Access Compliance Report

Public Rights-of-Way

(Curb Ramps)

Intersection ID: 10038782	Main Street: STEELE_CREEK_RD	Cross Street: N/A	Location: NW
ADA ID: CA147D00A6D0	Ramp Type: PerpDiag	Initial Pass/Fail: Fail	Overall Compliance: No
		Severity Score: 12.5

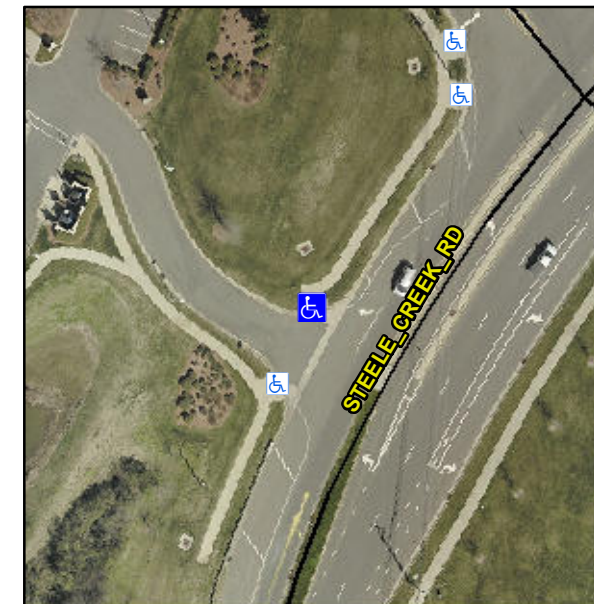
Not Found, R304.2.2

Remove & Replace Curb Ramp With Two New Directional Ramps or Equivalent.
